Information Only Service Note

N9042B UXA Series Signal Analyzer

A16A3 Reference OCXO Replacement Part Now Available

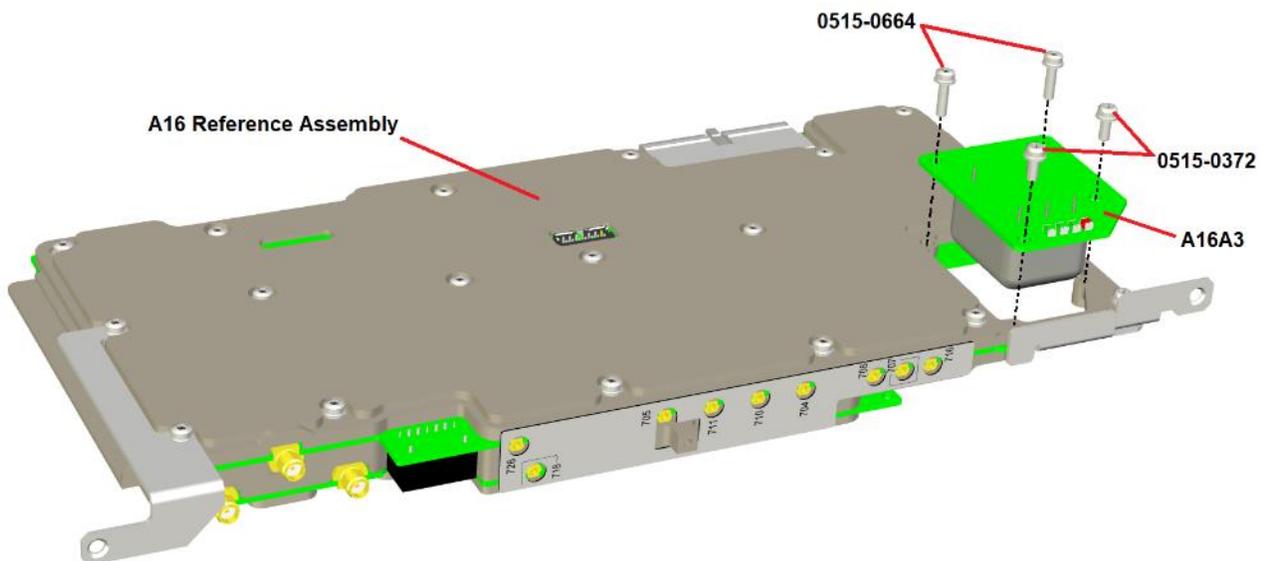
1. Follow the directions in the instrument service guide to remove the A16 Reference assembly from the instrument.
2. Referring to the figure below, remove the four screws shown to remove the A16A3 Reference OXCO from the A16 Reference assembly.

3. Install the replacement A16A3 Reference OXCO onto the A16 Reference assembly, being careful to properly plug the 26-pin interface connector in.
4. Reinstall the four screws, torquing them to 9 in-lbs.
5. Follow the directions in the instrument service guide to replace the A16 Reference assembly into the instrument.
6. Unless stated otherwise in the Post Repair Procedures chapter of the instrument service guide, perform all the tasks specified for the A16 Reference assembly replacement.
